Technical News 164
July 2015
Strictly Confidential

Contents

Description: Balancer Oil Cooling Jets and Crankcase Spares Kit

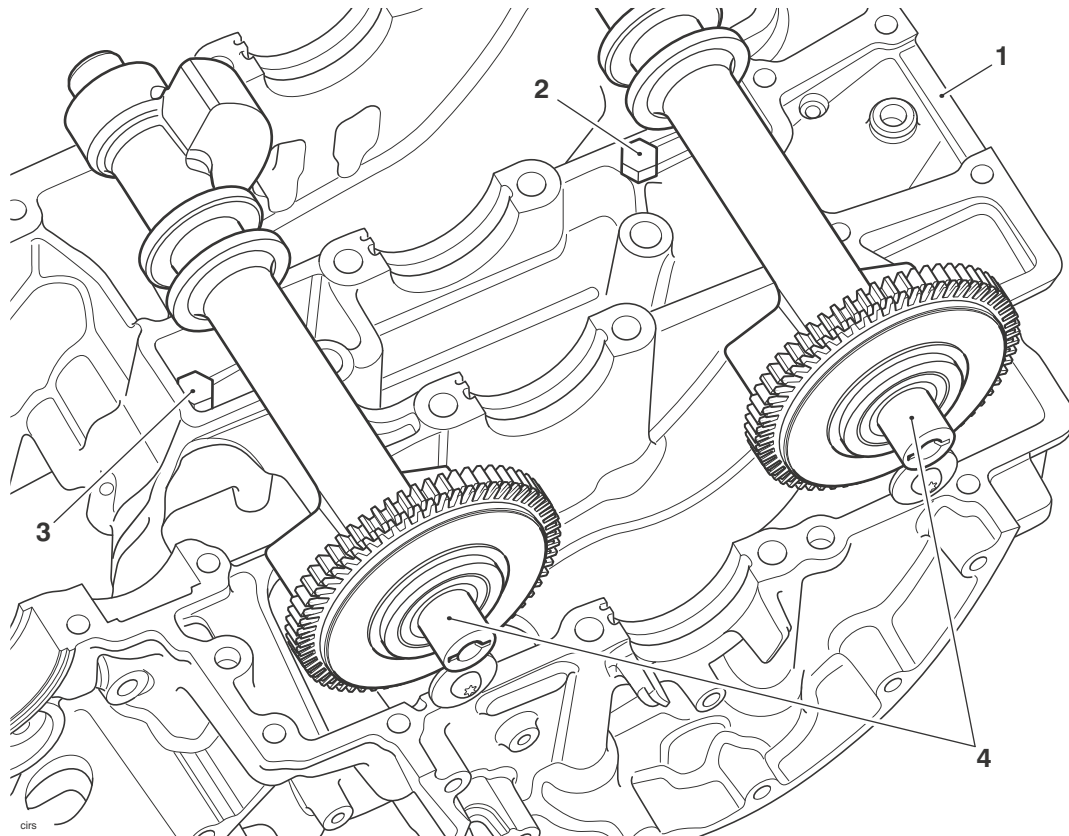
A new crankcase assembly has been introduced for the above models from engine number 713402. The new assembly features modifications to the crankcase castings. As a result, both front and rear balancer shaft oil cooling jets have changed from M6 to M8.

The new M8 oil cooling jets are not retrofittable and parts will continue to support the old condition M6 oil cooling jets for models already in service. The balancer shaft oil cooling jets should be tightened as follows:

- Old condition M6 oil cooling jets - **5 Nm**
- New condition M8 oil cooling jets - **6 Nm**.

- **Models already in service need not be retightened unless the oil cooling jets have been loosened or removed.**
- **If loosened or removed for any reason, the oil cooling jets must be replaced.**

- **Parts will no longer support old condition crankcases and any replacement will be the new condition.**

A crankcase parts kit comprising the new crankcase assembly and balancer shaft oil cooling jets has been released for use when replacing crankcases on the above models up to engine number 713401.

Description: Rider's Seat Fitment
Models affected: All Tiger XR and Tiger XC Models

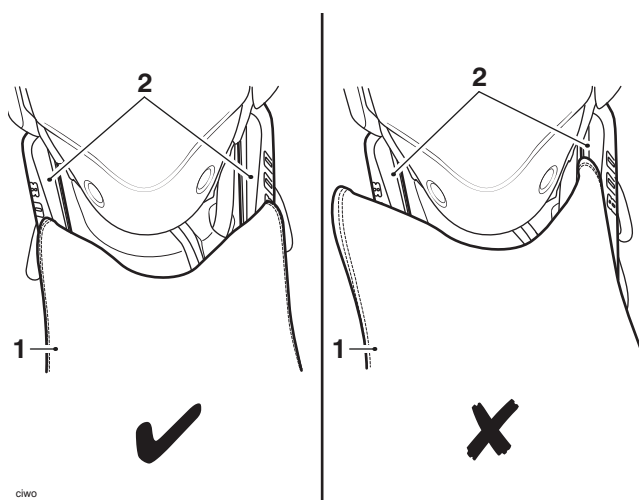
It has come to our attention that the rider's seat can become damaged on the above models, if care is not taken to correctly position the seat over the fuel tank infill panels during installation.

Take care when installing the rider's seat. Always ensure that the seat is correctly positioned over the fuel tank infill panels, before attempting to engage the seat's mounting rails.

Dealers are advised to install the rider's seat as described in the Owner's Handbook, noting that care should be taken to correctly position the seat over the fuel tank infill panels before attempting to engage the seat's mounting rails.

Description: Handlebar Clamp Fixings
Models affected: Thunderbird Commander and Thunderbird LT

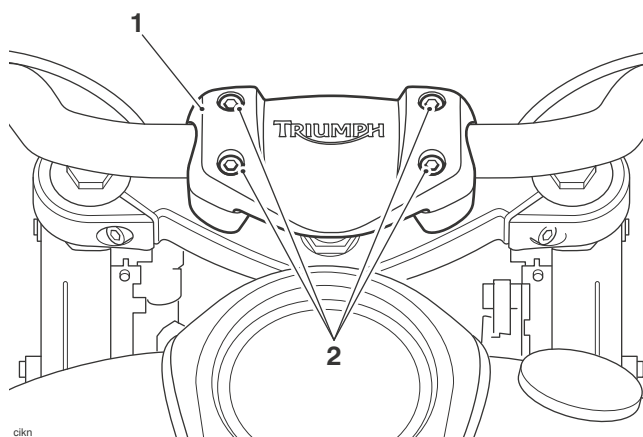
The torque figure for the handlebar clamp fixings has changed to **27 Nm** on the above models.

- **Models already in service need not be retightened unless the fixings have been loosened or removed.**
